# Work Change Proposal Request

Oak Street Lofts  
72 Oak Street  
Portland, ME 04101

ARCHITECT'S PROJECT NUMBER: 07.446

**SKA-3**

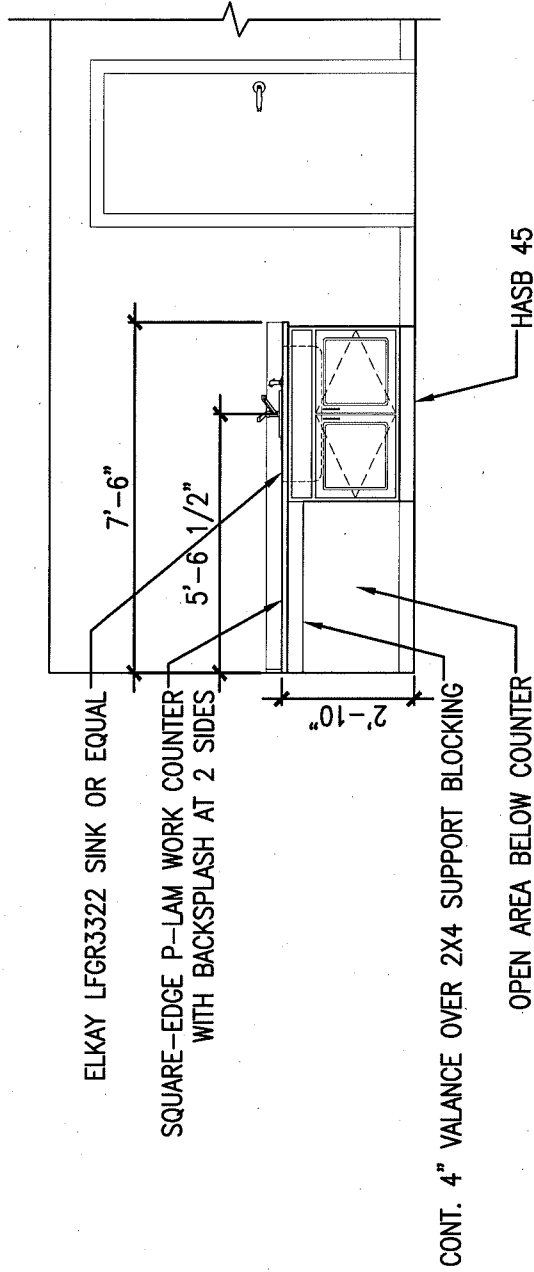
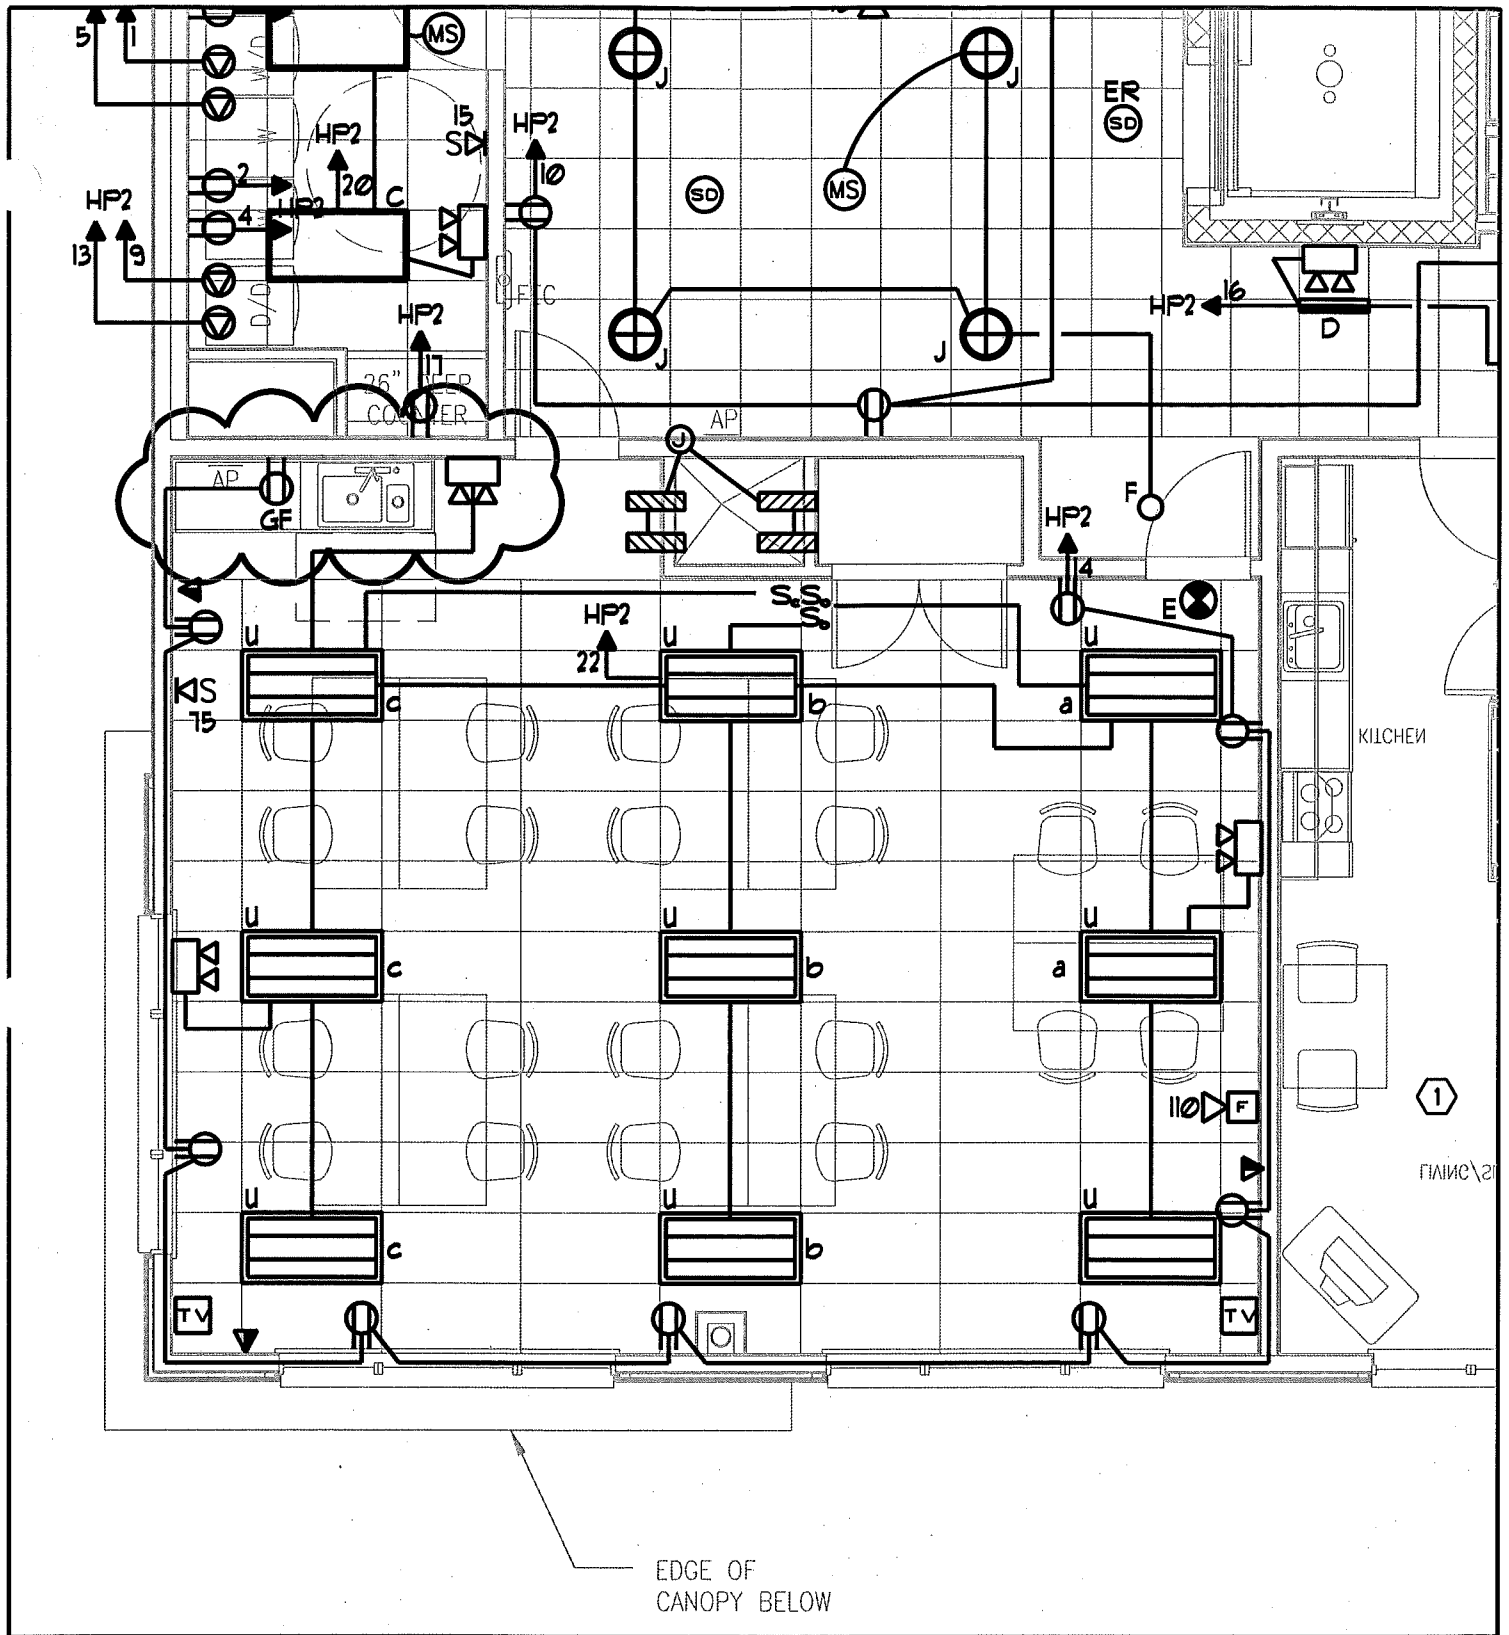
Provide and install all components of a work counter with sink on base cabinet as per the attached SKA-3, SKE-2 and SKM-3.

SKM-4

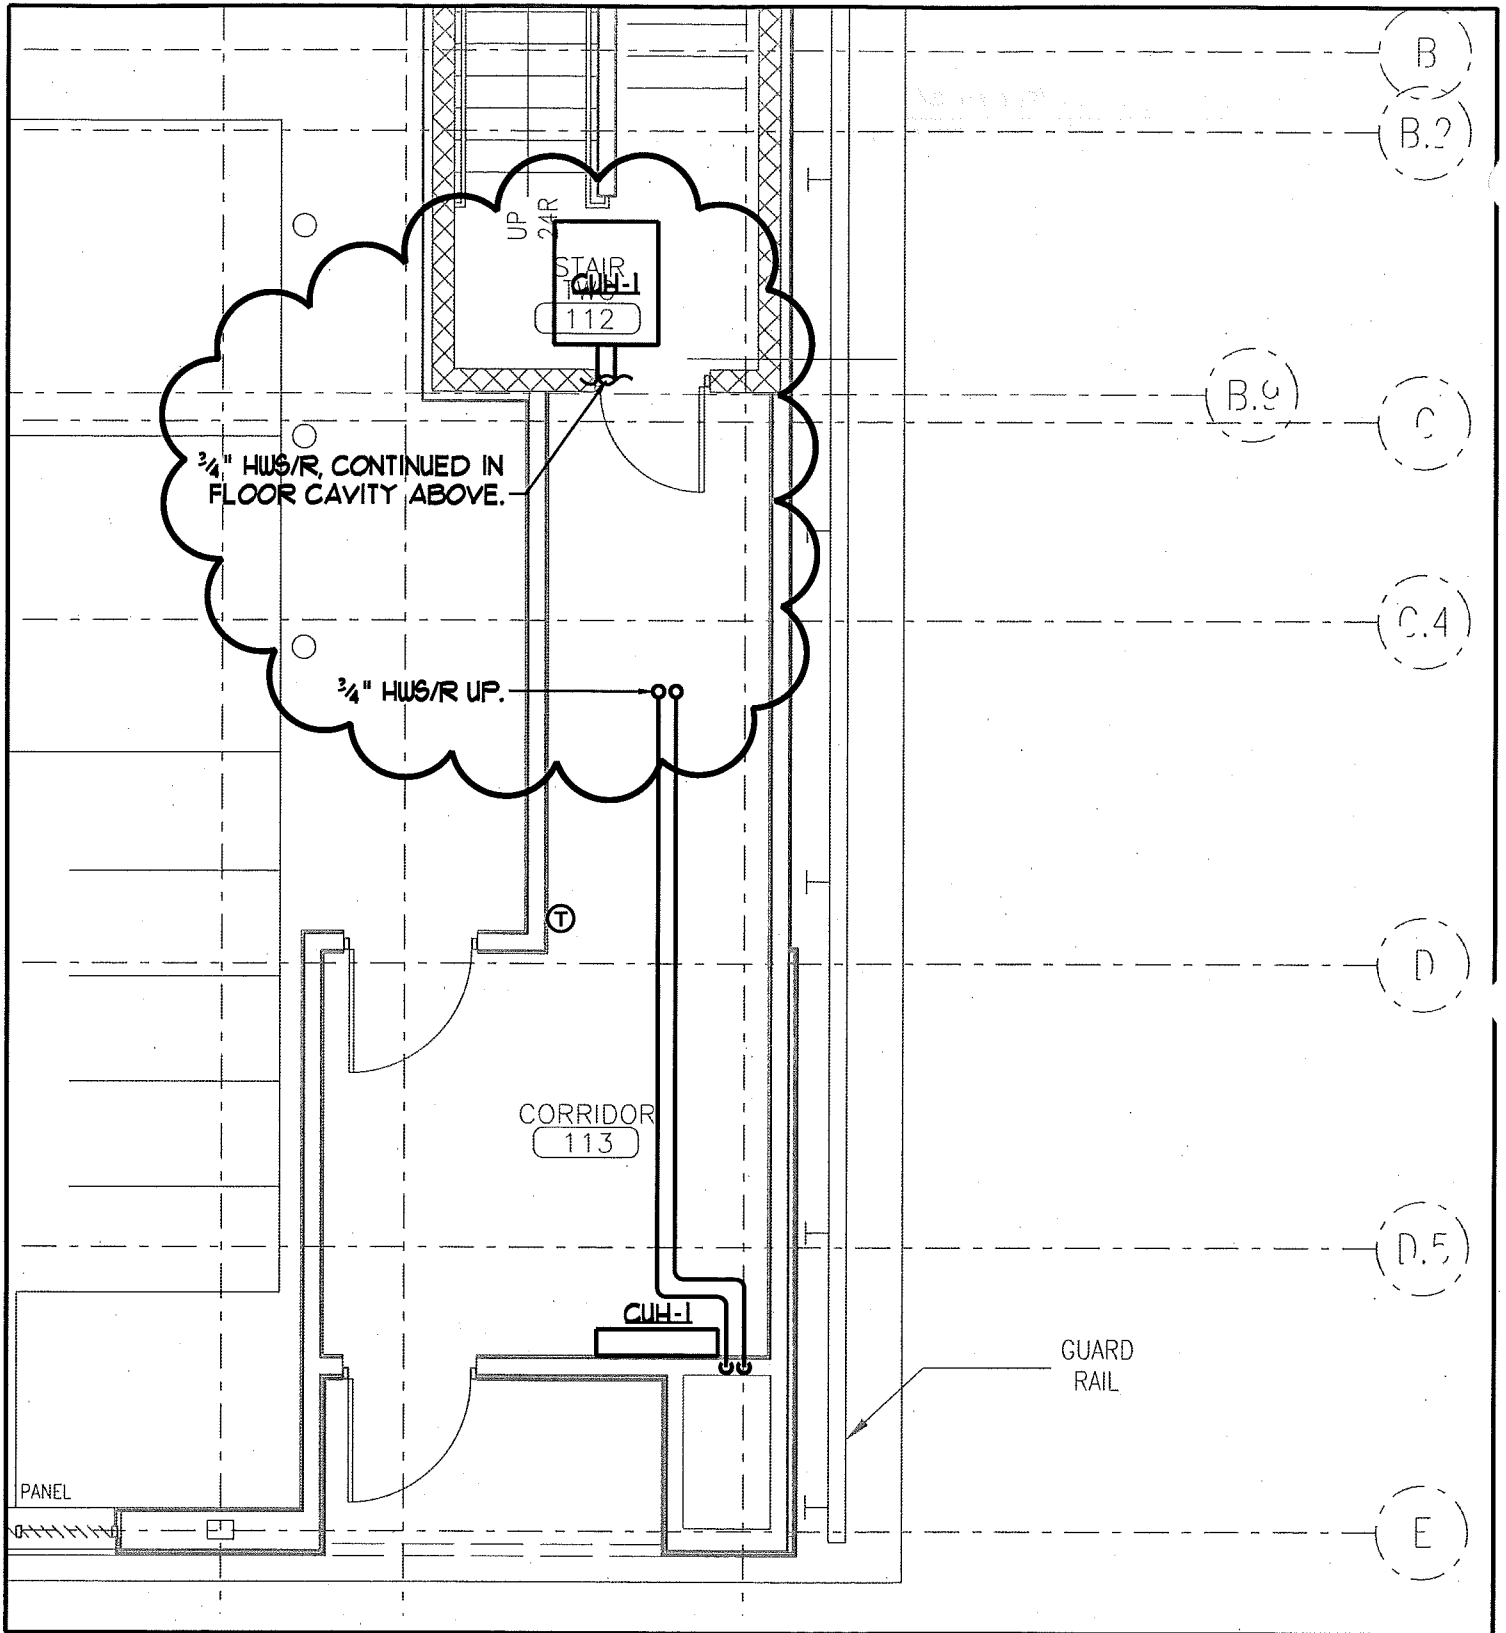
Provide and install Sterling ceiling mounted cabinet unit heater Model C1140-03 (2GPM) at Stair Two First floor ceiling in lieu of the specified wall mounted unit. Modify supply piping as indicated by the attached SKM-4 and SKM-5.

CSK-4

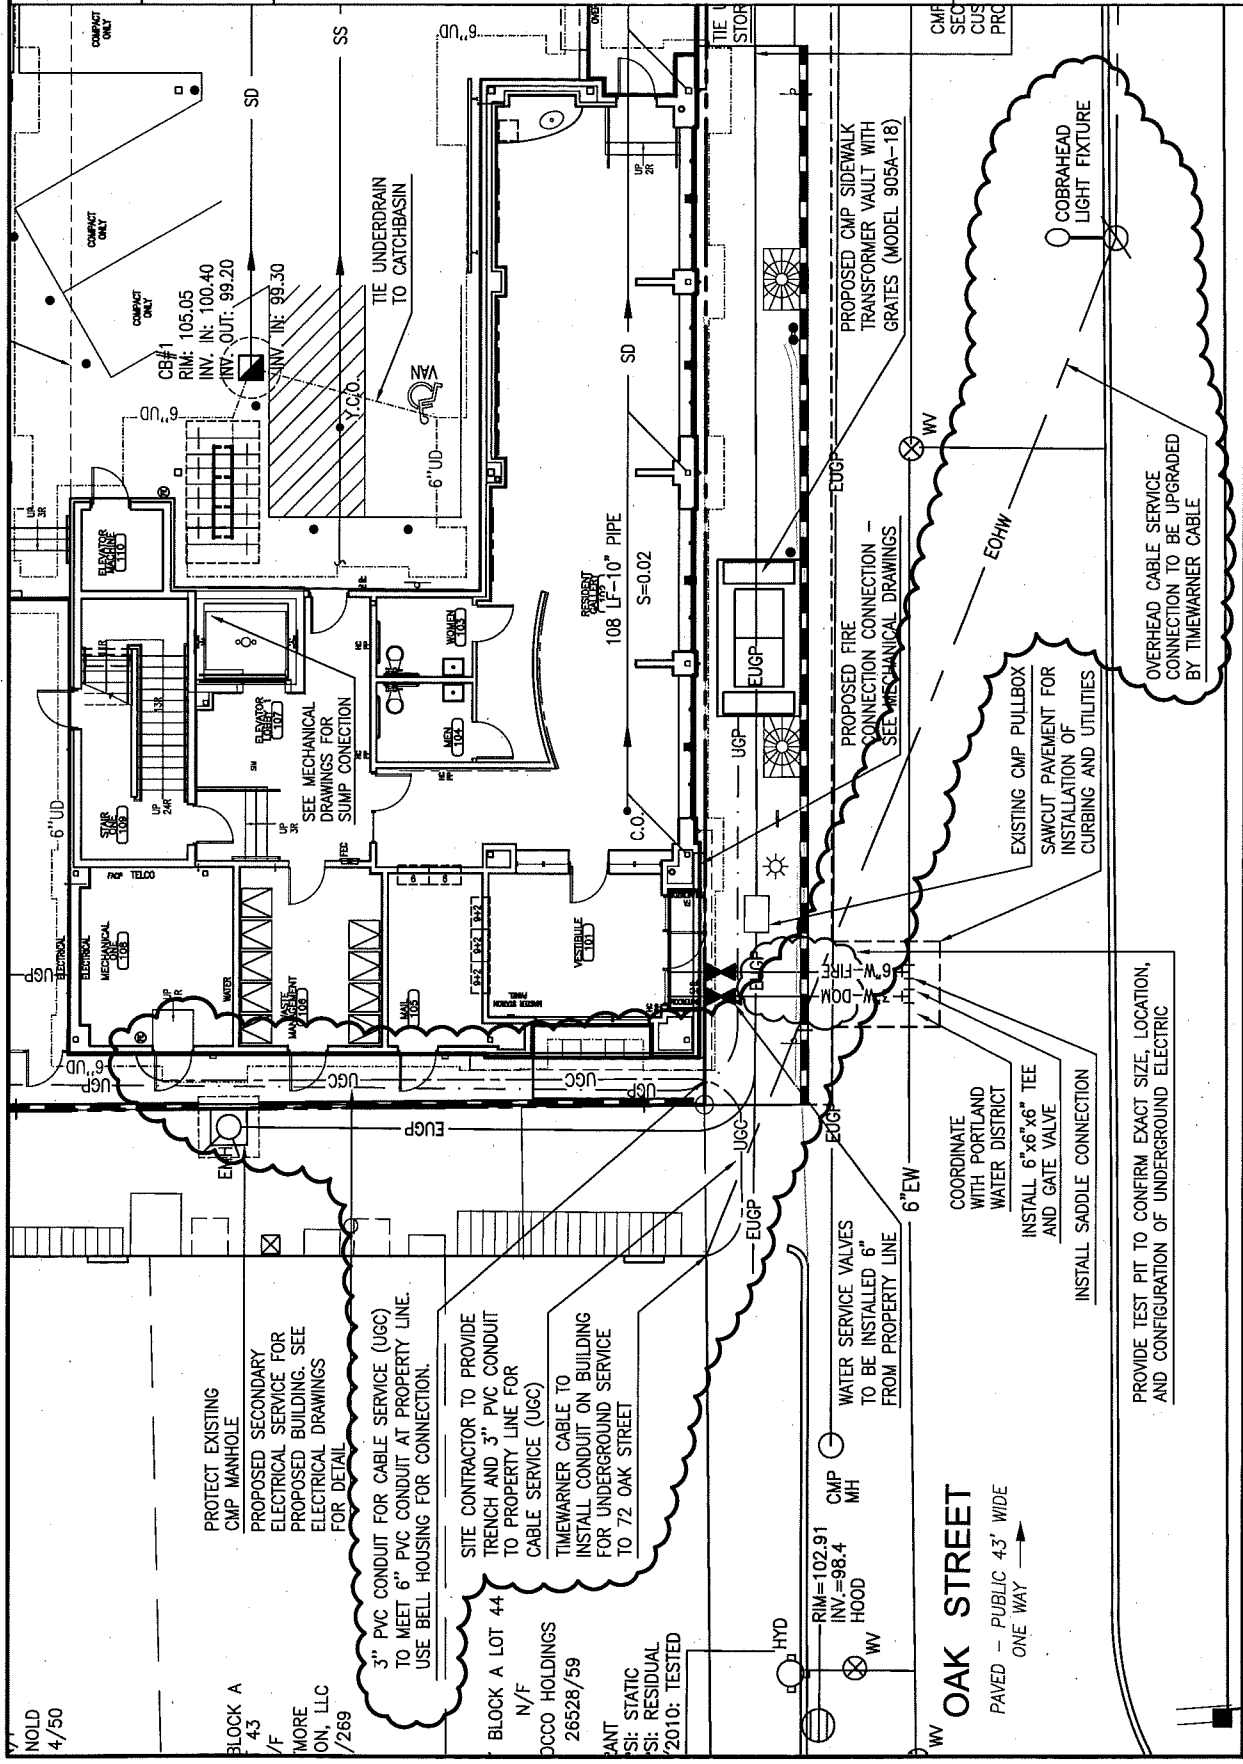
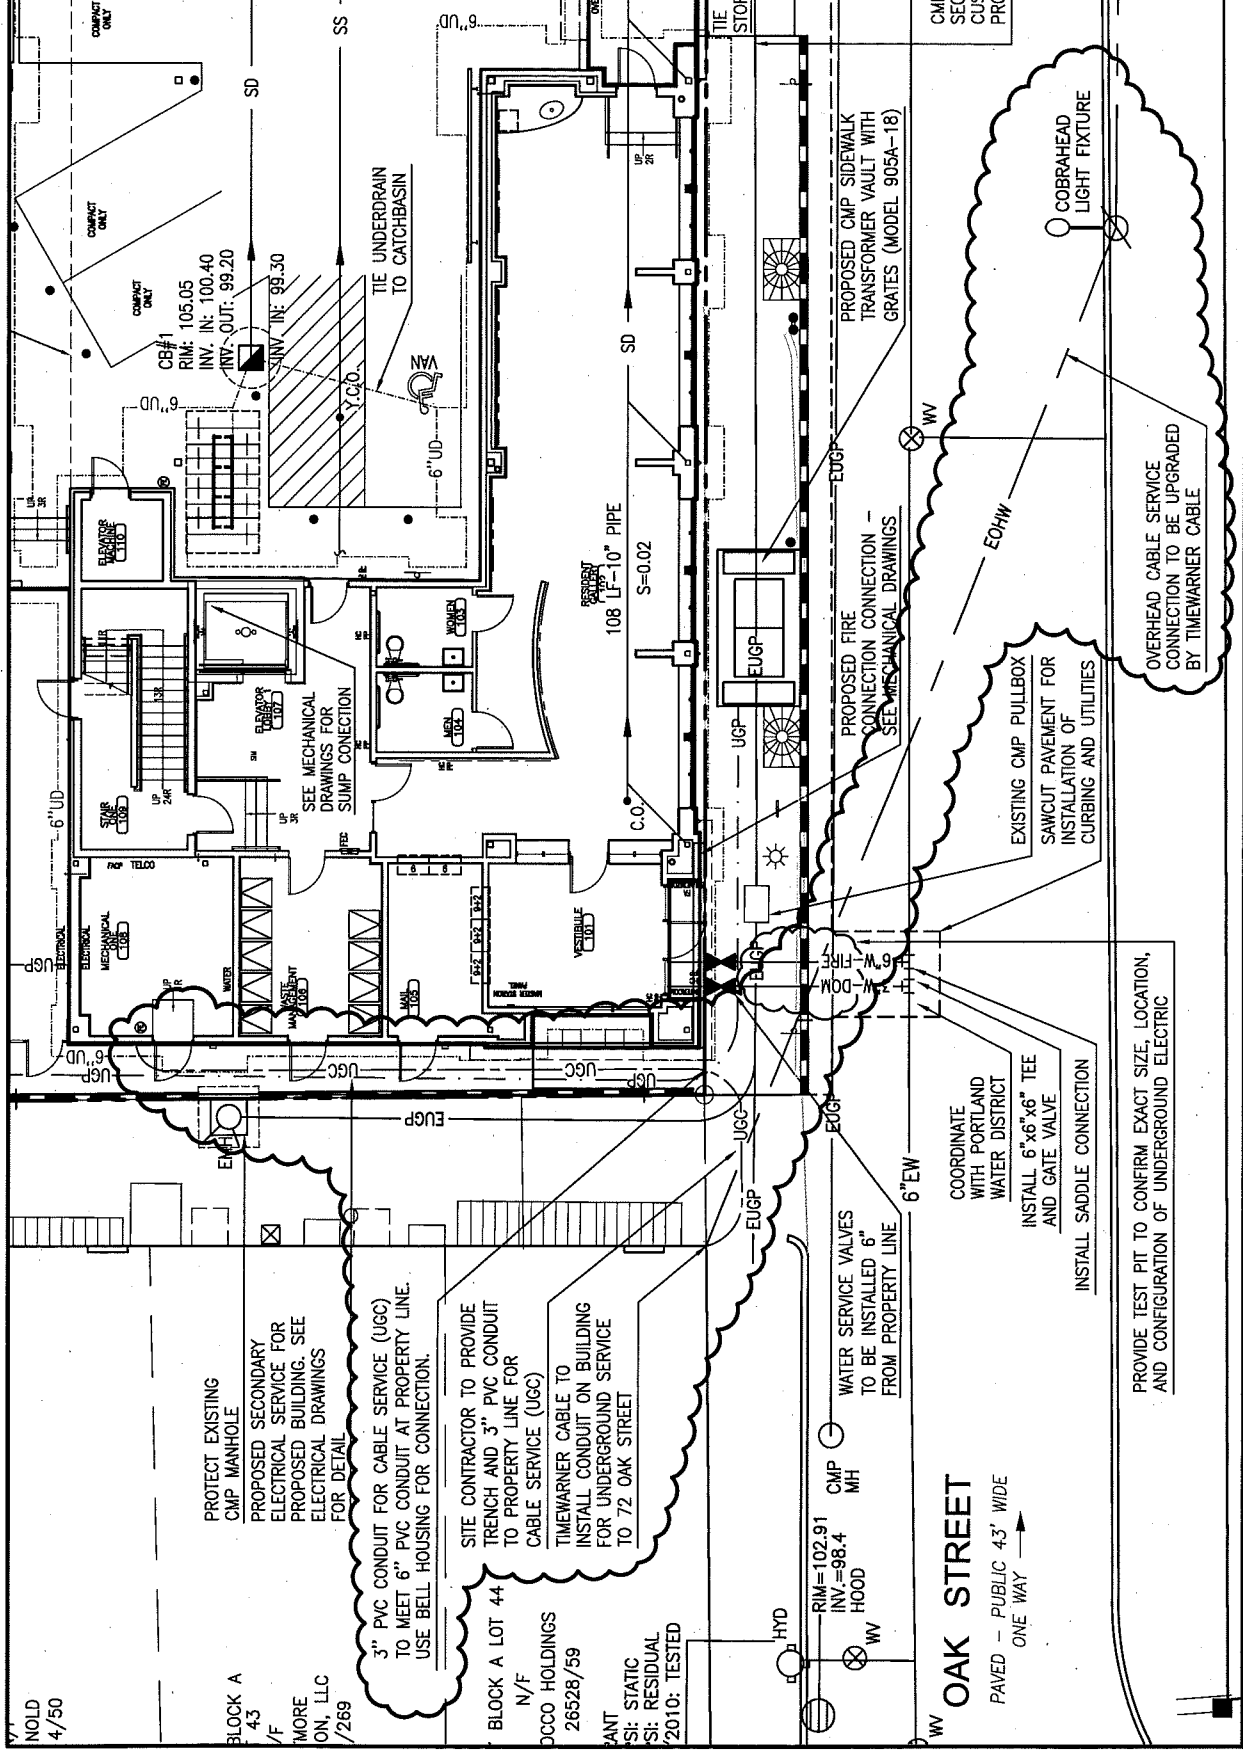
Provide and install conduit from the northeast corner of the alley to the mechanical room as indicated on the attached CSK-4. This conduit shall be a substitution for the 1 1/2" conduit shown in CSK-1 and SKE-1.
